Subject: CHECK ENGINE LIGHT ON WITH DTC P2610 AND P2507	Bulletin No: 01-018/15
	Last Issued: 08/06/2015

- This bulletin supersedes the previous bulletin 01-001/13 issued on 01/07/13, 01/16/13 and 09/25/13 and 01-017/14 issued on 10/17/14. The APPLICABLE MODEL(S)/VINS, DESCRIPTION, REPAIR PROCEDURE and WARRANTY INFORMATION have been revised.
- Changes are noted below in Red beside the change bar.

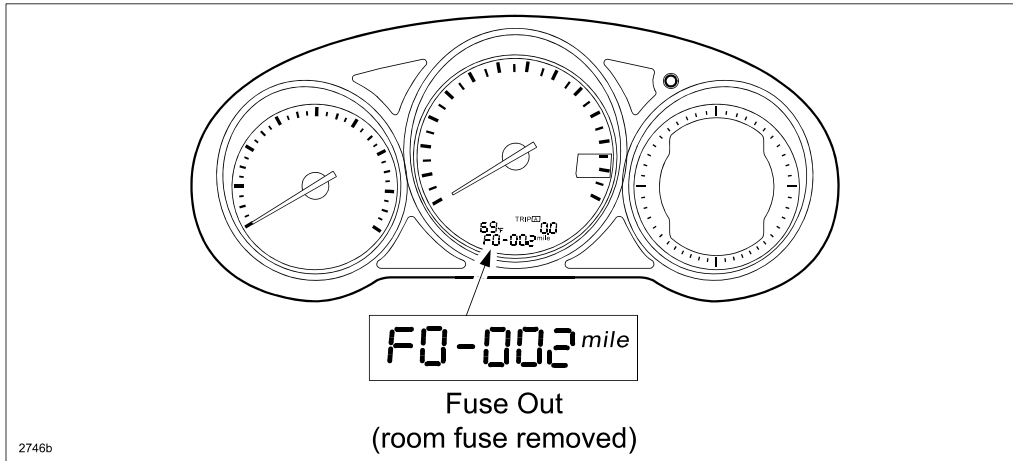
Some vehicles may experience the CHECK ENGINE LIGHT ON with DTC P2610 and P2507 stored in memory after engine start and room fuse 15A (A) removed.

This is caused by the engine being started 3 or more times after a short duration of engine off (less than 15 seconds) with the room fuse removed.

NOTE: The odometer will display "F0-002" during transport mode (room fuse 15A removed). Transport mode is canceled when room fuse 15A is installed or the vehicle odometer is more than 12.4mi (20km).

1. Verify DTC P2610 and P2507 are stored in PCM memory.
2. Install ROOM fuse 15A with ignition OFF.
3. Start the engine and let it run for at least 10 seconds, then stop the engine.
4. Start the engine again and verify that the CHECK ENGINE LIGHT is not illuminated, then stop the engine.
5. Clear DTC P2610 and P2507 from PCM memory using IDS.
6. Verify no other DTCs are stored in memory. If so, troubleshoot them according to the MS3 online instructions or Workshop Manual.
